COLORADO DIVISION OF RECLAMATION, MINING AND SAFETY
MINERALS PROGRAM INSPECTION REPORT
PHONE: (303) 866-3567

MINE NAME: Craig Pit	MINE/PROSPECTING ID#: M-1976-027	MINERAL: Sand and gravel	COUNTY: La Plata
INSPECTION TYPE: Monitoring	INSPECTOR(S): Kate A. Pickford	INSP. DATE: March 12, 2014	INSP. TIME: 10:00
OPERATOR: Skanska USA Civil West Rocky Mountain D	OPERATOR REPRESENTATIVE: Shad Peabody	TYPE OF OPERATION: 112c - Construction Regular Operation

PHOTOGRAPHS

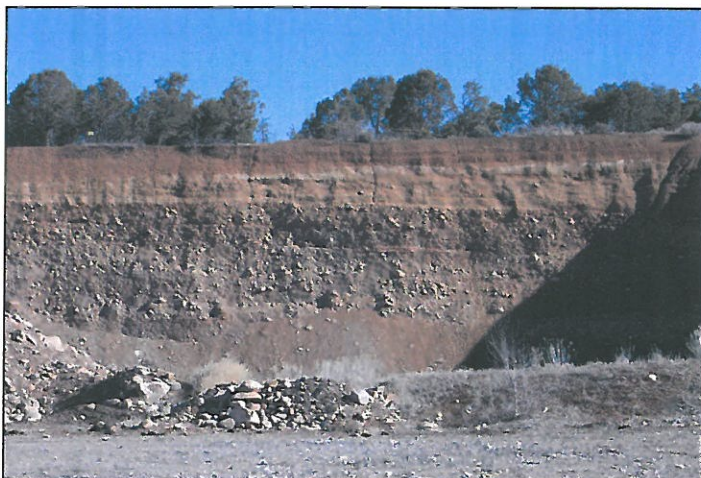
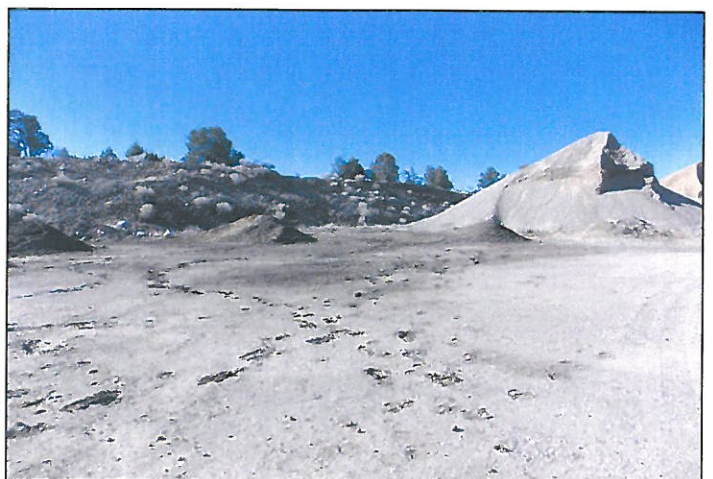
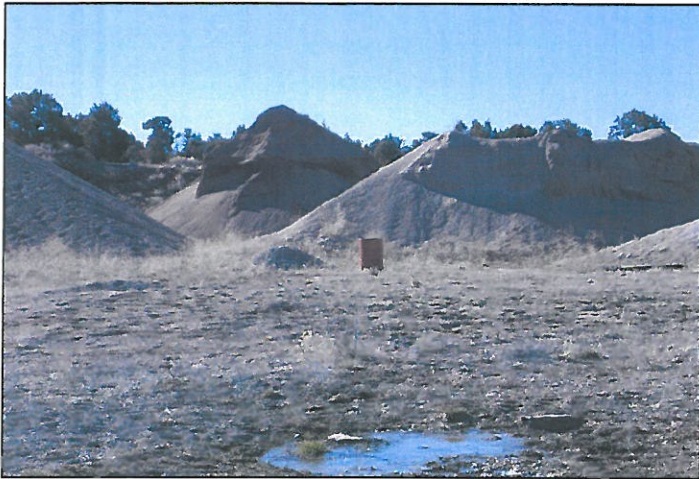
There is a large amount of disturbance at the site. Stockpiles are present along the pit floor. There is a highwall over 70 feet in height located very close to a ranch road on top that is not to be disturbed. This requires backfilling some of the highwall from below. At the base of the highwall is an even deeper pit. Skanska plans to fill the pit with construction by products from other sites. The operator must comply with Rule 3.1.5 (9) when importing materials from offsite to use as backfill in the pit.
